UNITED STATES PATENT AND TRADEMARK OFFICE

APPLICATION NO.	FILING DATE	FIRST NAMED INVENTOR	ATTORNEY DOCKET NO.	CONFIRMATION NO.
10/517,276	04/16/2005	Gerhard Klein	2213 0084US	2818
29894	7590	12/13/2005	EXAMINER	
DREISS, FUHLENDORF, STEIMLE & BECKER POSTFACH 10 37 62 D-70032 STUTTGART, GERMANY			NGUYEN, GEORGE BINH MINH	
		ART UNIT	PAPER NUMBER	
		3723		
DATE MAILED: 12/13/2005

Office Action Summary	Application No.	Applicant(s)	
	10/517,276	KLEIN, GERHARD	
Examiner	Art Unit		
George Nguyen	3723

DETAILED ACTION

With reference to Figure 3, Boulton discloses the claimed invention including:

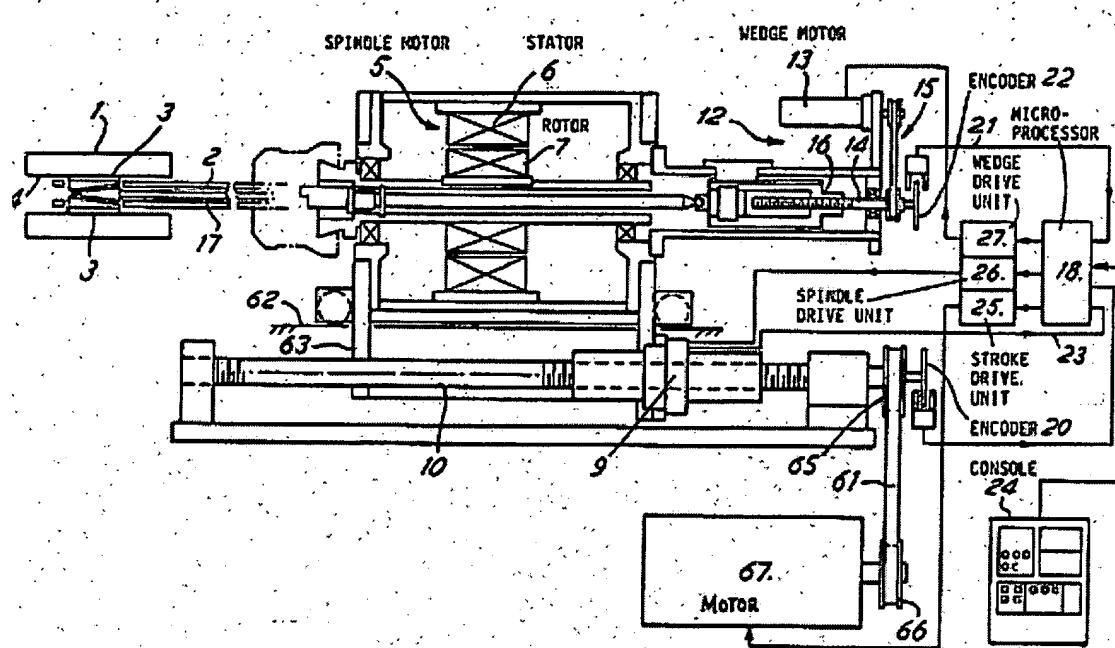
2. Claims 4 and 6 are rejected under 35 U.S.C. 103(a) as being unpatentable over Boulton et al.'4,823,061 in view of Klein et al.' 5,042,202 and Heijkenskjold'6,176,767.

- A spindle housing not reference numbered having a honing spindle disposed in said spindle housing.
- A first electromotor 5 for rotating said honing spindle.
- A bar disposed in said honing spindle.
- A second electromotor 6 for reciprocating said honing spindle.
- A third electromotor to axially displace said bar to widen a honing tool 3.

However, Boulton does not disclose an electromotor coaxially flanged to an end of said spindle housing, nor does Boulton disclose a linear motor reciprocating said spindle housing.

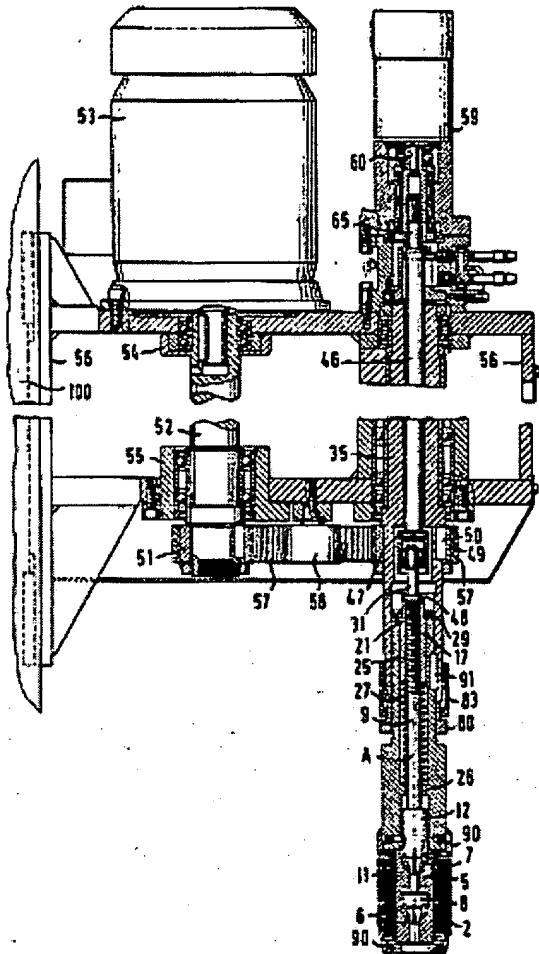
With reference to Figure 1, Klein discloses a reciprocating honing apparatus comprising an electromotor 59 coaxially flanged to an end of spindle housing 56 to axially displace bar 9 to widen honing tool 2. The advantage of the coaxial installation of motor 59 is to provide a direct drive to bar 9 in order to make the grinding apparatus more compact, thus reducing footprint of the grinding apparatus.

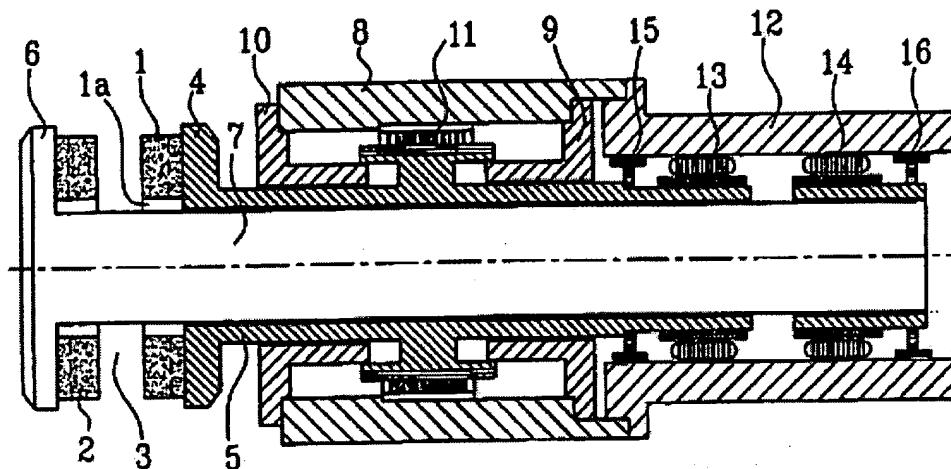
With reference col. 1, lines 20-30, Keijkenskjöld discloses an abrading apparatus comprising linear motors 13/14 for axial displacement of shafts 5/7. The advantage of linear motor is to provide a machine that is very compact, thereby improving the rigidity and exactness of the machine (col. 1, lines 24-25).
